TECHNICAL BULLETIN INDEX
Sorted by Bulletin Number
06/25/86

DATE: January 10, 1983
REVISION DATE: January 10, 1983
BULLETIN NO.: 12/16B:1
PRODUCT: 26-4004/5 (Model 12)
SUBASSEMBLY: Motorola Video Board

Figure 1

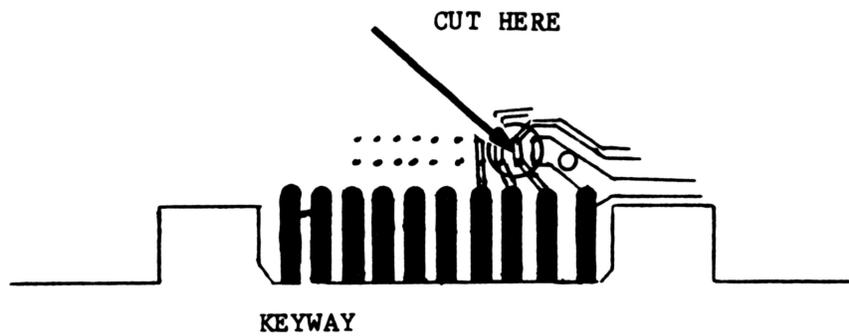
PROCEDURE: The modification consists of a jumper that connects pin 2 of P1 to pin 5 placed in the holes closer to the edge connector as shown in figure 1. Then a cut must be made between the 2 holes in the trace that is connected to pin 2 which will disconnect pin 2 from the rest of the PC board as shown in figure 2.

Jumpers for the Main logic board for use with another computer (Direct Wire) & the ALTEST DB25 connector
Figure 2:

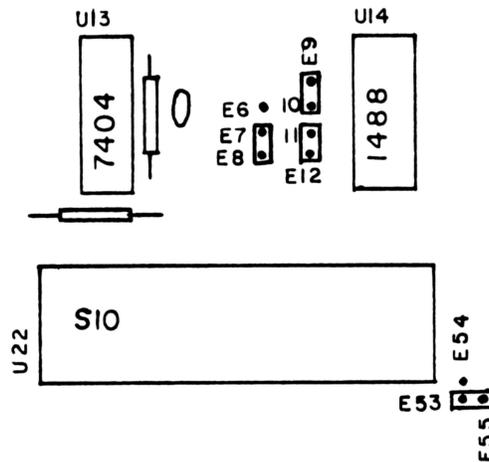
Remove jumpers E10-E11 and E53-E54 and install jumpers E53-E55, E9-E10, and E11-E12 as shown on page 4 in figure 2. You will need an additional jumper, National Parts part number AJ-6769 jumper plug. If these are not in stock wire wrap can be used instead.

If it is going to be used with a modem the main logic board should be modified as shown in figure 3 by removing E10-E9. If it is going to be wired directly to another computer it should be left as in figure 2. Also, it is recommended that the customer use a 12 conductor cable on their serial channel instead of a 25 conductor cable.

Loopback connector modifications

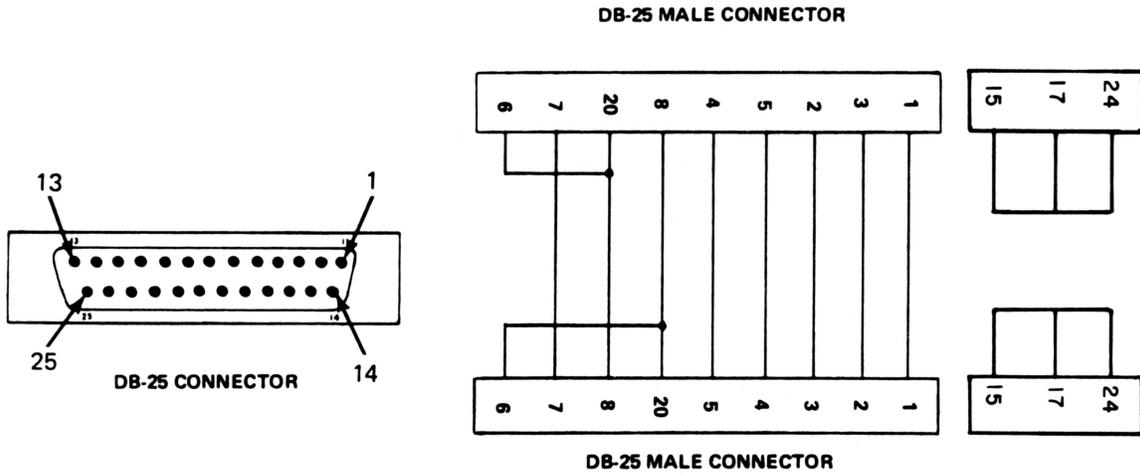
The loopback connector used with AUTO3 should be modified as shown on page 5. The connector will then be usable on both BISYNC and async computers. Run AUTO3 or the Model II family System Test on the modified computer with the modified loopback connector to verify the hardware and jumpers.

Schematic changes

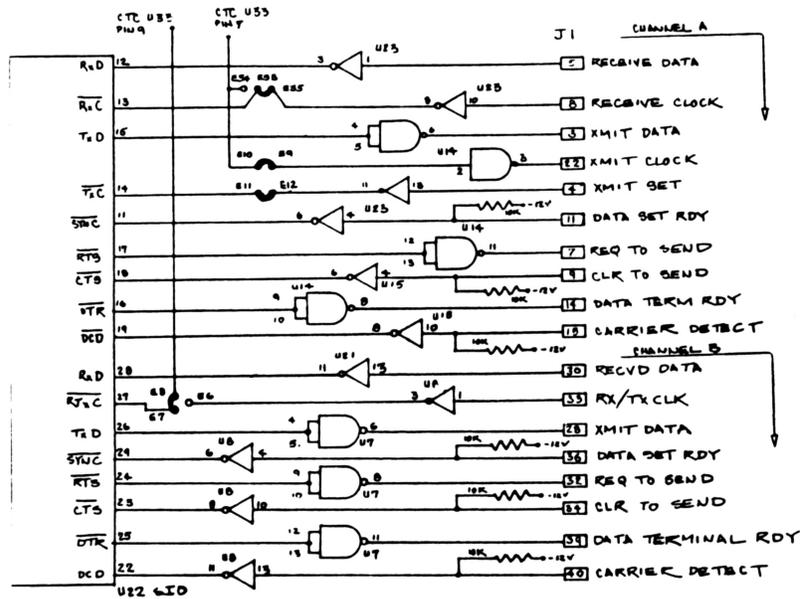
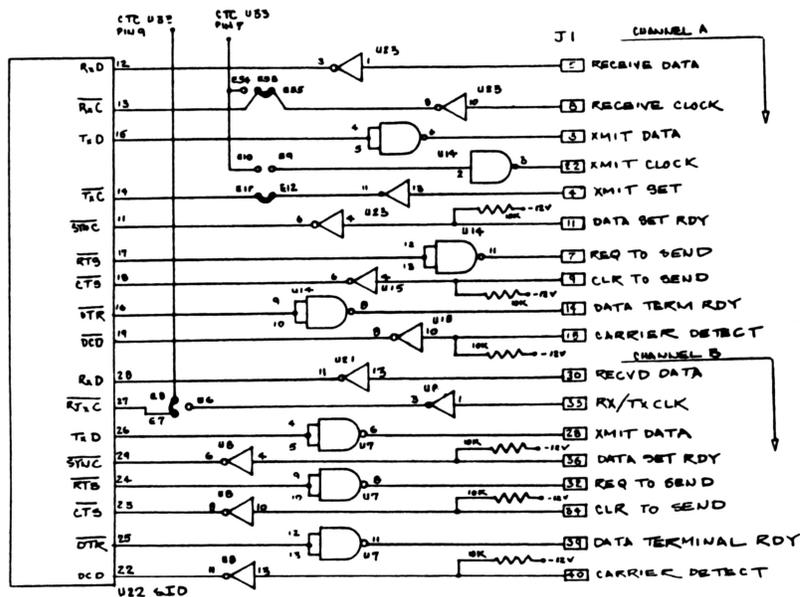
Looking at the schematic on page 6, the new jumper positions take the transmit clock for channel A and connects it to pin 24 of the DB25 for channel A. This breaks the connection between the transmit clock and the SIO chip. The transmit clock will now be provided by the modem through pin 15 of then DB25 connector (I/O XMIT S.E.T.). The clock for the receive section of SIO channel A now comes from pin 17 of the DB25. This means that we are now using two sections of U23 and one section of U14 that have been previously unused.

Figure 1

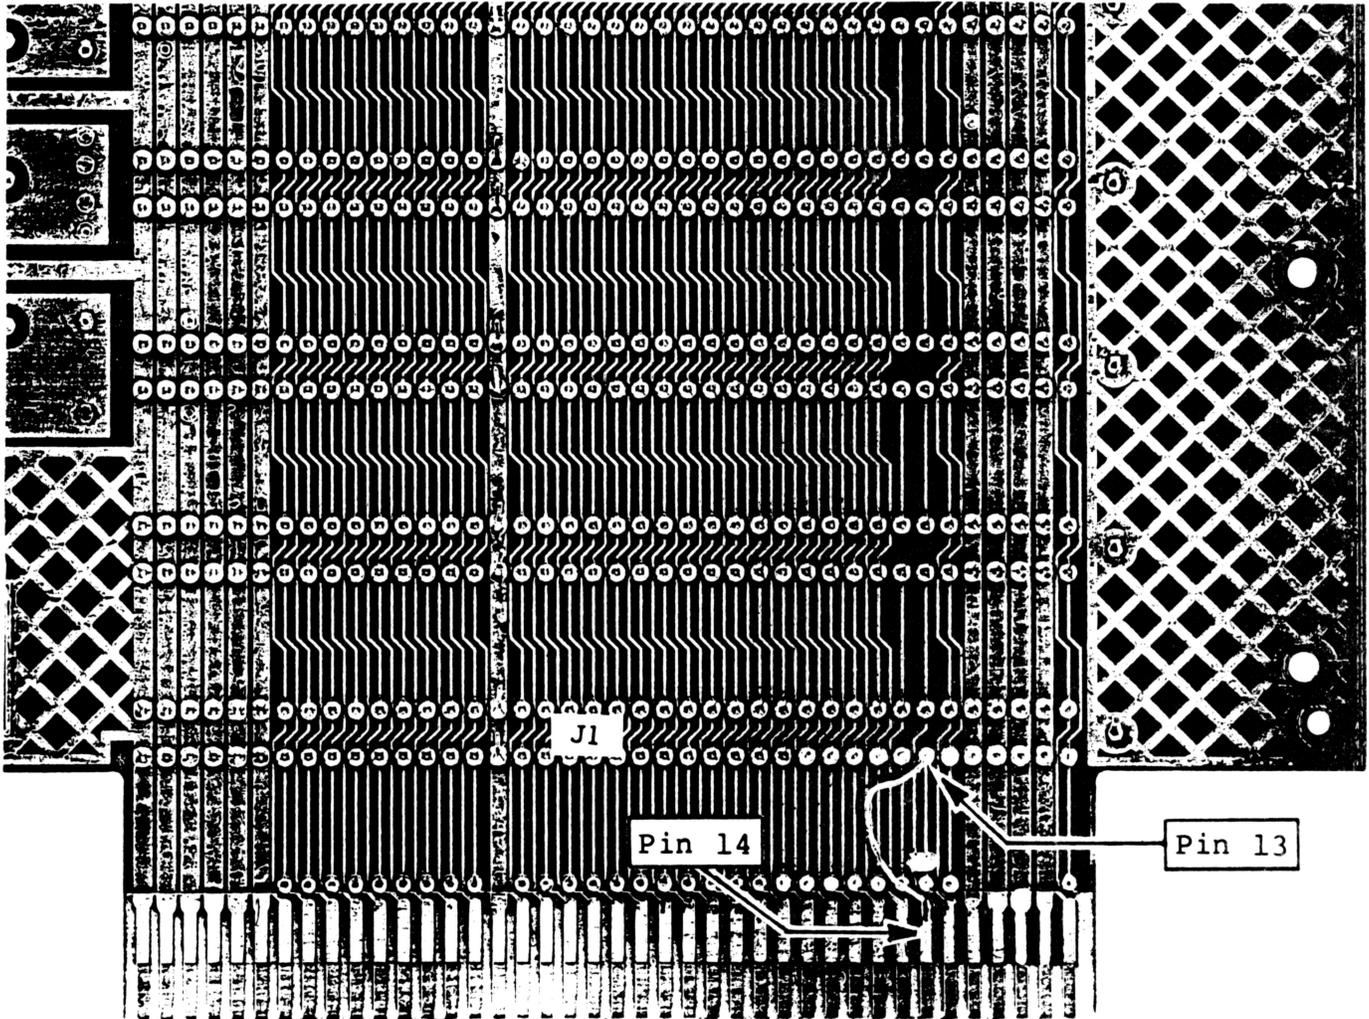
DISCUSSION: An error in the artwork of the mother board (revision PP4), will cause the 1st slot of the mother board to not function properly when a board using Z-80 family interrupts is installed.

PROCEDURE: Just above the point where the mother board plugs into the main logic board cut the two traces going to pins 13 and 14 of the plug (figure 1). Then run a jumper from pin 14 of the plug that goes into the mother board to pin 13 of the first socket in the mother board (J1).

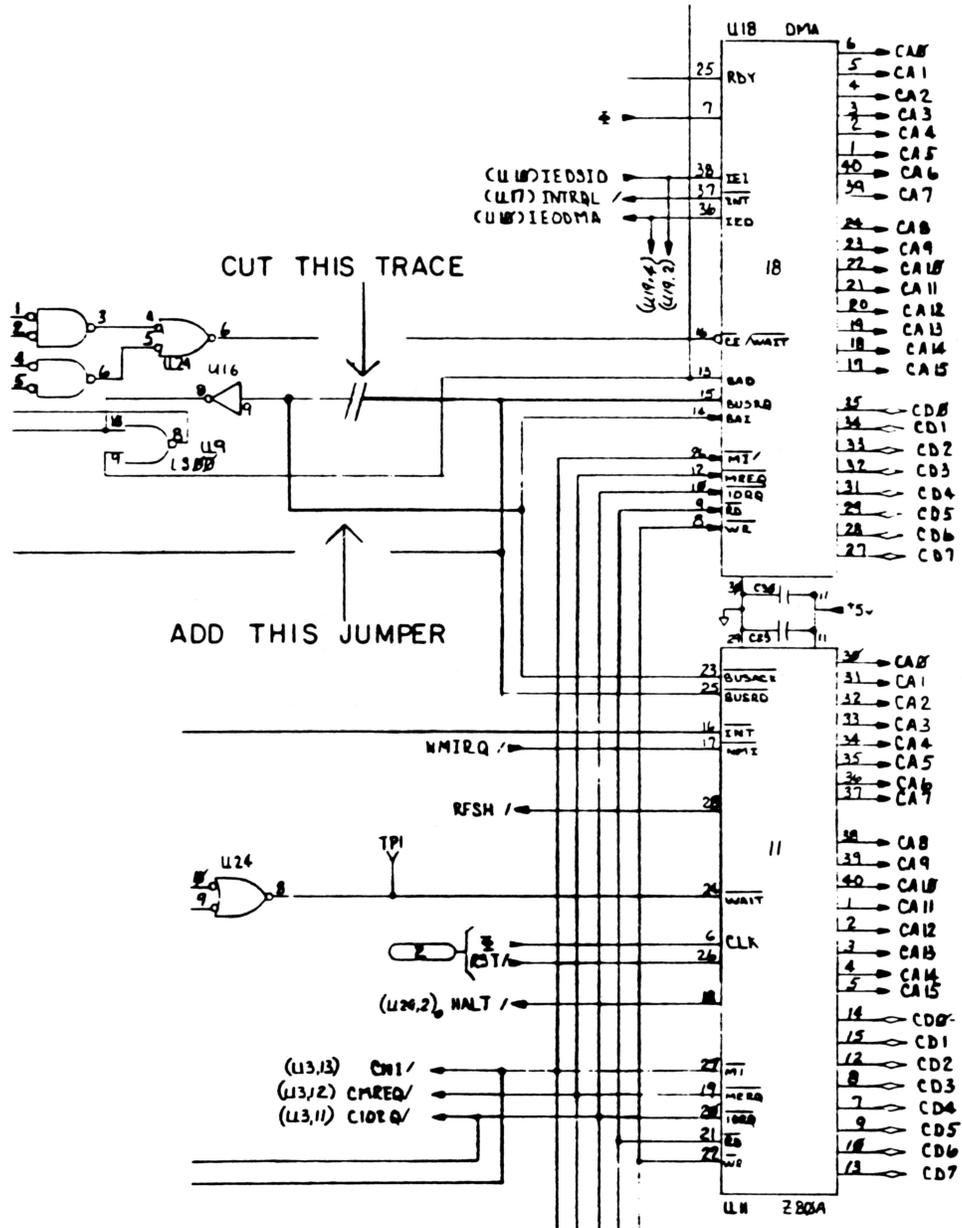
The DMA is being inadvertently selected at times causing 'garbage' to be written to the control registers. The modification described below will keep the DMA from being selected and will keep the Model 12/16B from locking up. **This modification applies to all Model 12/16B's with a Rev. PP3 or Rev. Blank main logic board.**

Cut the trace connected to U16, pin 9 right at the pin on the solder side of the board. Then connect a jumper from U16, pin 9 to the feedthrough connected to U11, pin 23.

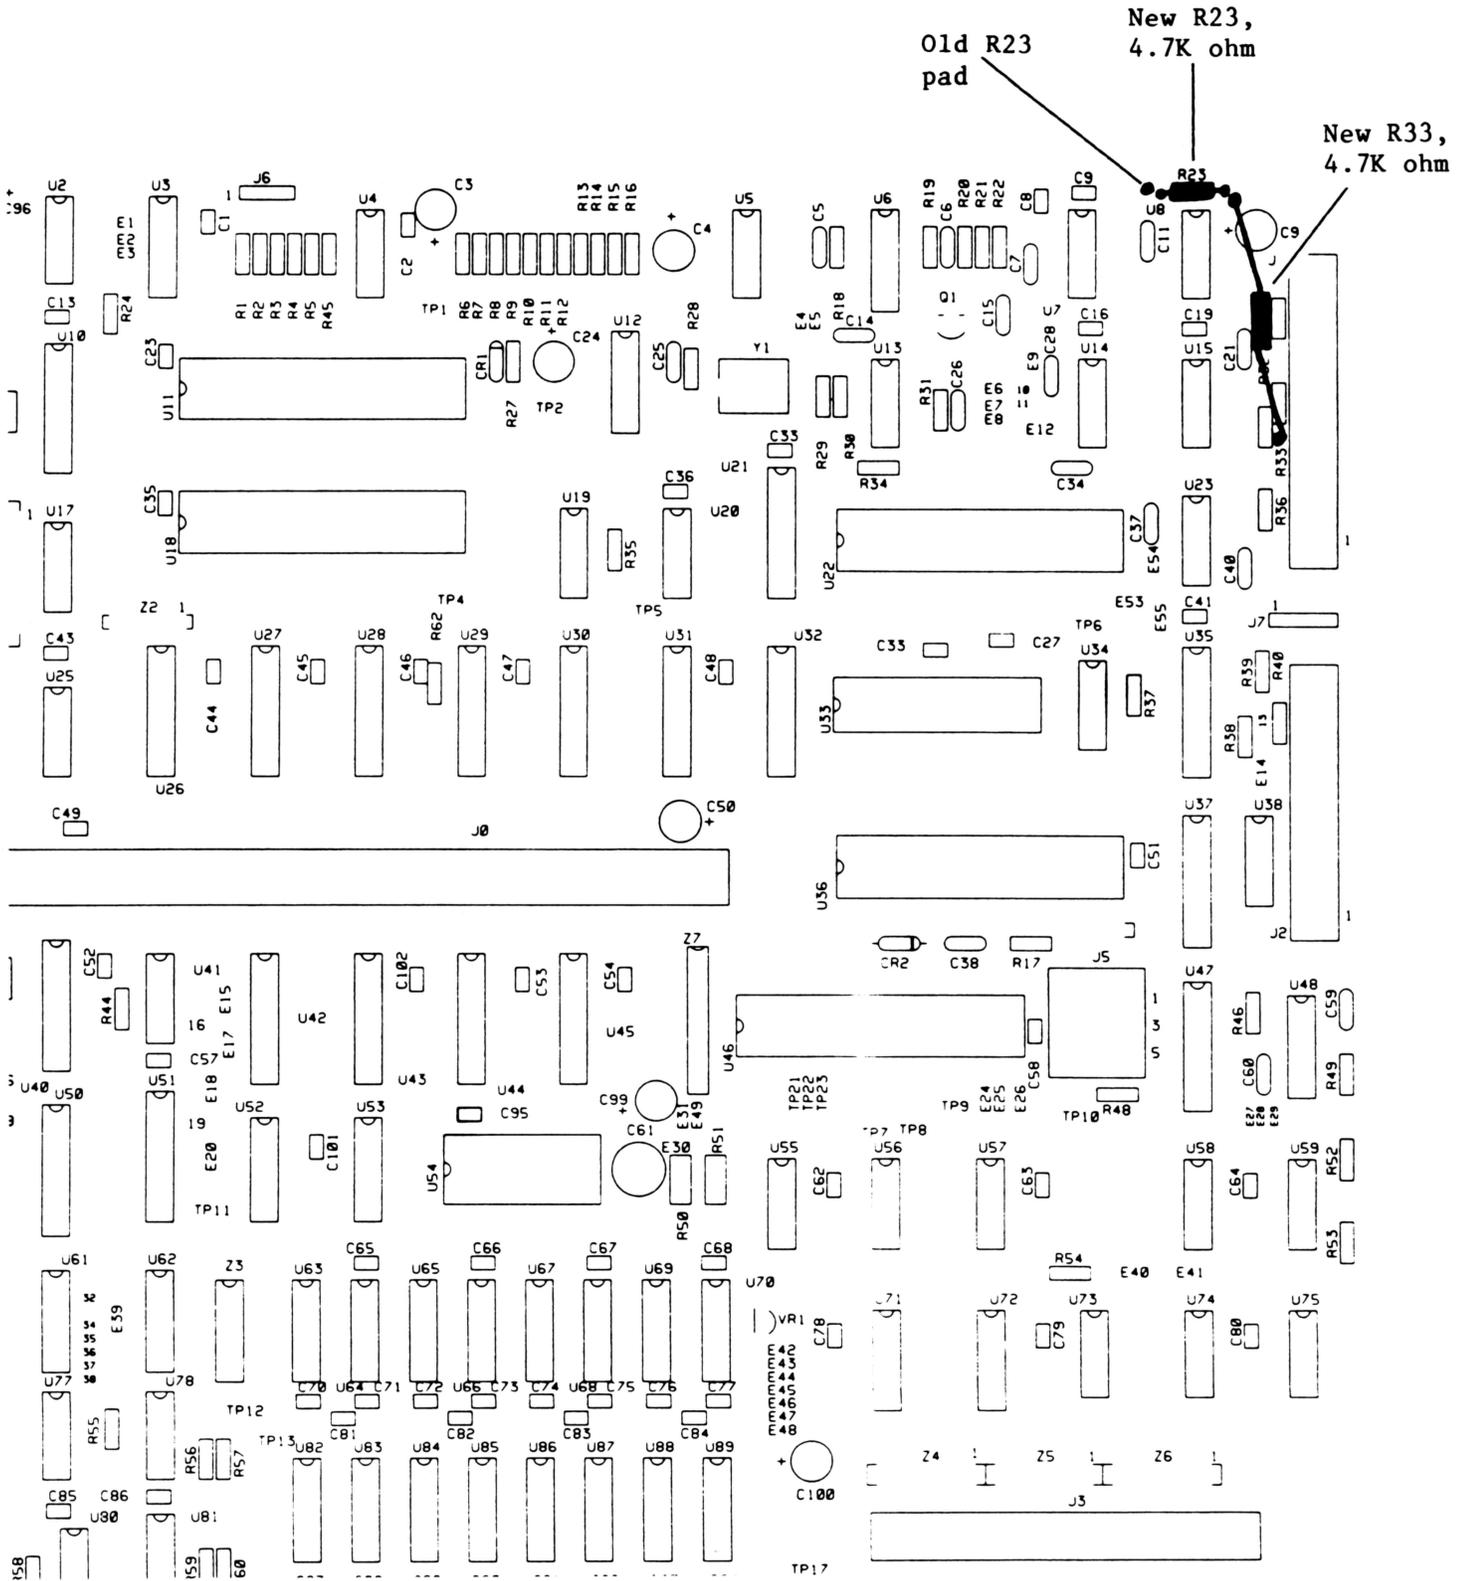
Change R21, R23, R25, R32, R36 from 10K ohm to 4.7K ohm resistors. Remove resistor R33. On the component side of the board, install a 4.7K ohm resistor with one lead attached to the old R33 solder connection closest to R36 and the other lead attached to the +12V line at the feedthrough adjacent to R23 between U8 and C97 (refer to figure 1). The leads should be insulated to prevent them from shorting.

Remove resistor R23. On the component side of the board, install a 4.7K ohm resistor with one lead attached to the old R23 solder connection closest to C97, and the other lead attached to the +12V line at the feedthrough adjacent to the remaining R23 solder connection. The +12V line in question also connects directly to U7, pin 14 (refer to figure 1).

Figure 1 Video PCB (component side)

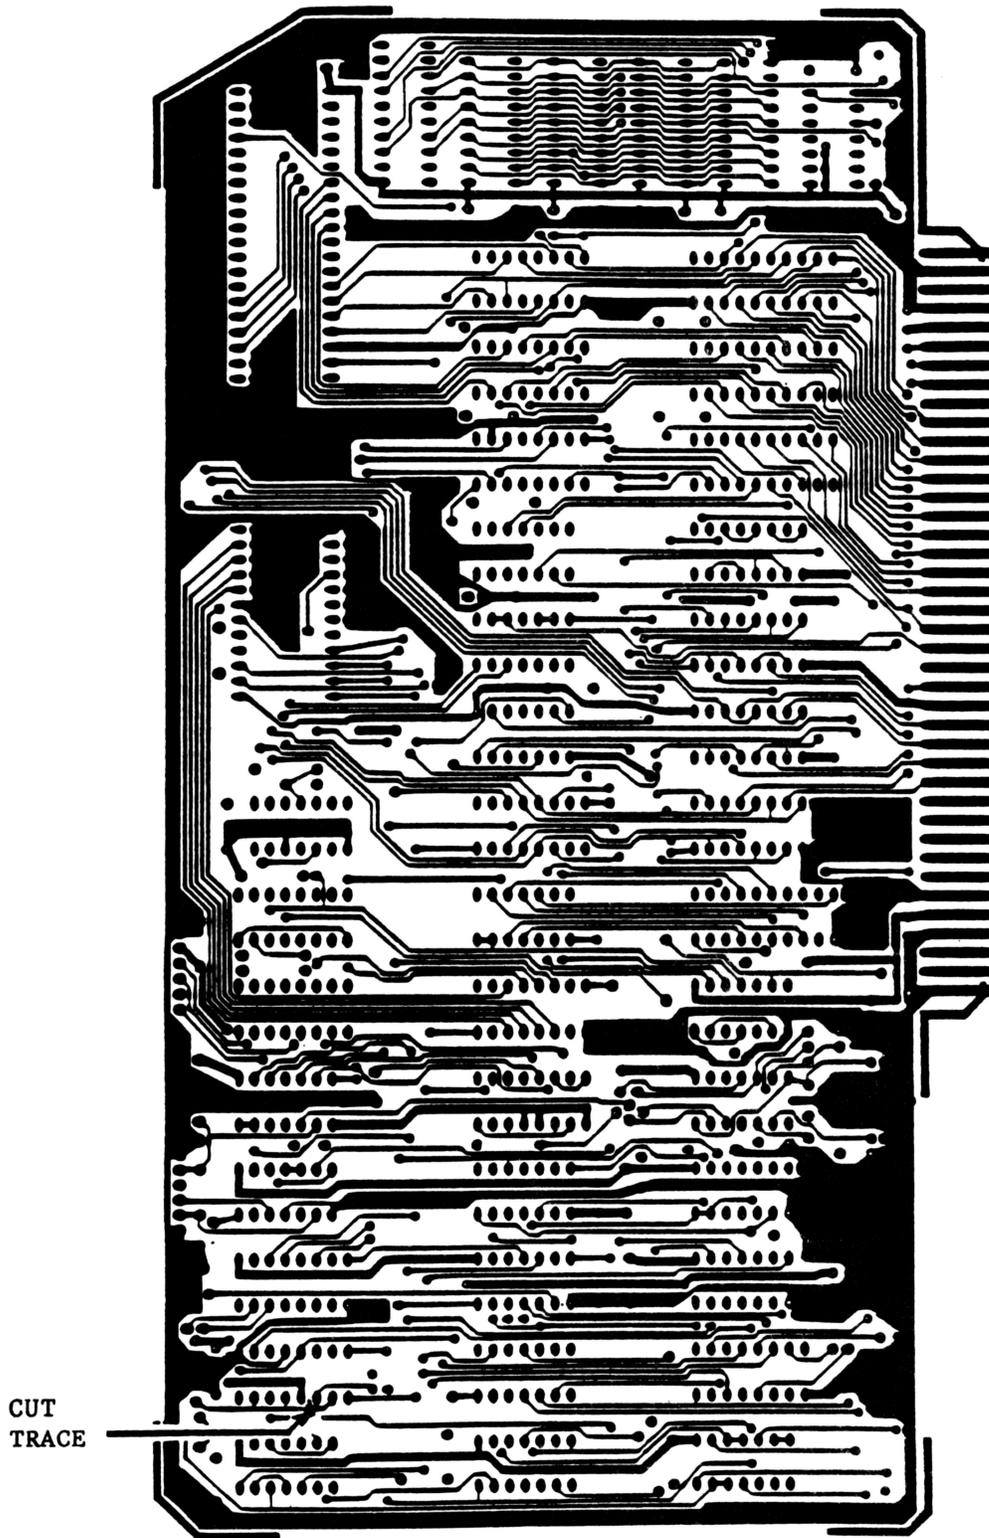
High memory addresses are shared by the Video and the 64K RAM. When the computer needs to use the video, it will activate the video RAM select logic allowing access to it. Occasionally when doing very fast RAM switching such as diagnostics, due to the access time specification of the RAM, the data transfer may not be reliable causing video failures. To correct this change the video select timing from 10ns to 100ns.

Refer to Figure 1 and cut the trace on the component side at U32 pin 7. Add a jumper wire from U32 pin 7 to U32 pin 12.

Figure 1

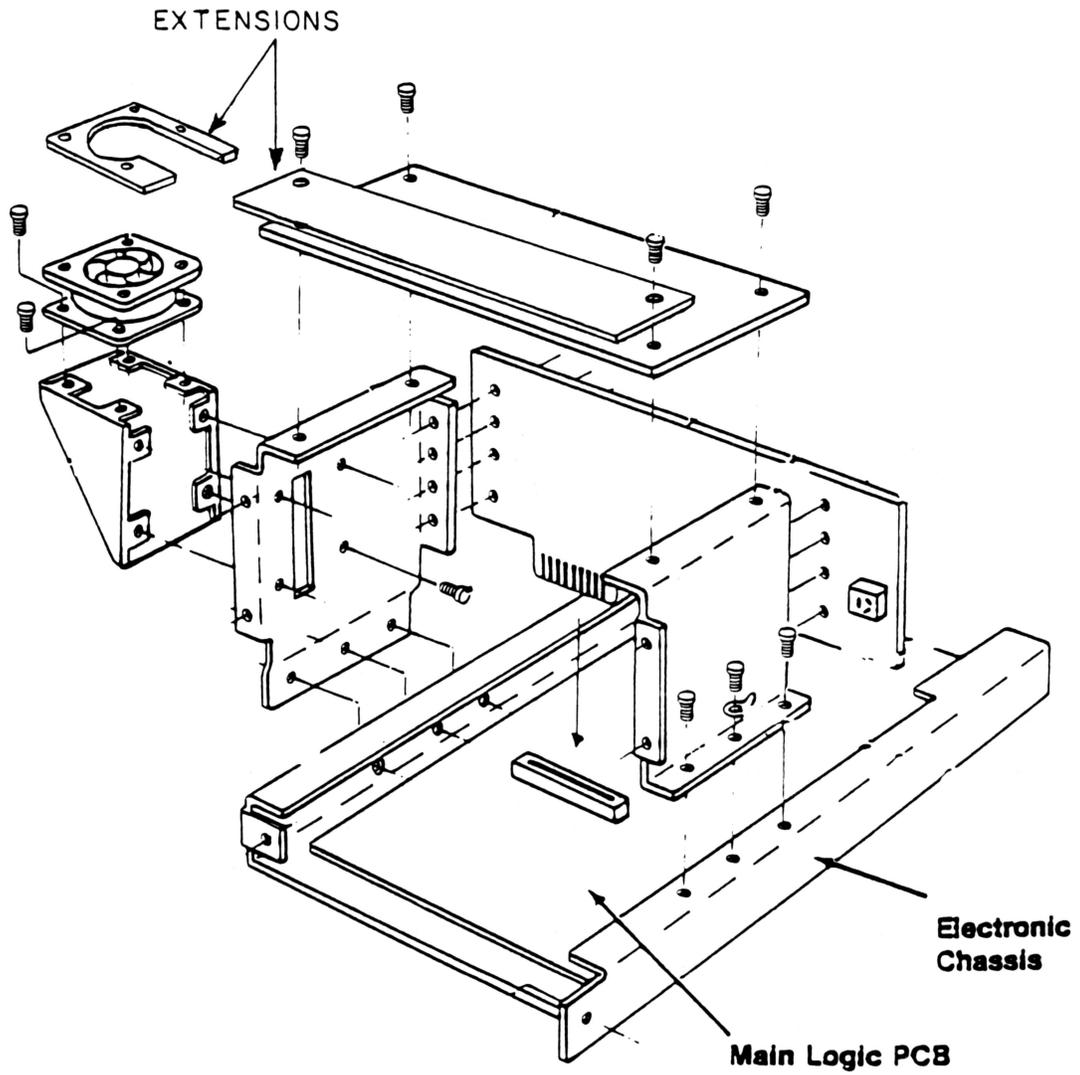
Refer to Figure 1 for the remaining steps.

2. Remove the 6 screws that hold the card cage to the chassis. Disconnecting the motherboard power plug and the fan wires will allow the card cage assembly to be pulled up and removed.
 3. Remove the top plate, fan flume, and motherboard.
 4. Replace the left and right side plates with the corresponding part numbers listed above.
 5. Reassemble the card cage and the computer and check for proper operation.
-
